**Reservoirs Act 1975  
2019 Annual Supervising  
Engineer's Statement under  
Section 12(2) and Section  
12(2A)**

Poynton Lake

4 October 2019

**Photo 4 – Leaning Trees along Upstream Face**

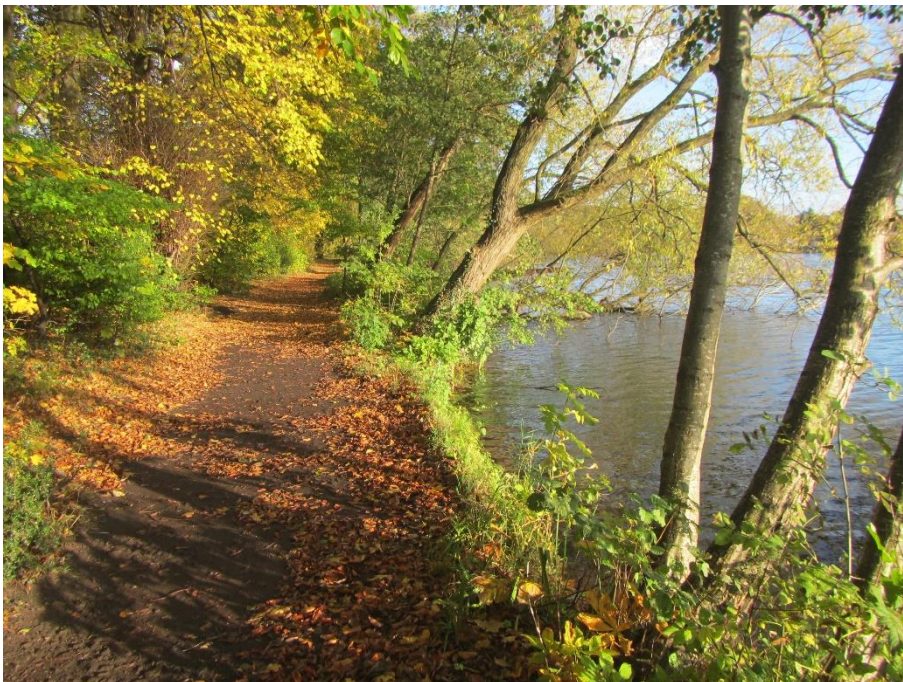
It was noted that tree management has been ongoing with a number of trees cut down and sections of the upstream face cleared of saplings. However, there are many leaning trees along the upstream face and a number of fallen trees (Photo 4). Fortunately, the crest is very wide and there does not appear to be a risk of the entire crest width being damaged by a fallen tree along the upstream face. **It is recommended that any fallen or leaning trees that are threatening the integrity of the face should be removed, along with any tree saplings before they become established.** When the roots and stumps have been cleared away, the upstream face should be reinstated to the correct line and new revetment boards should be installed to provide erosion protection.
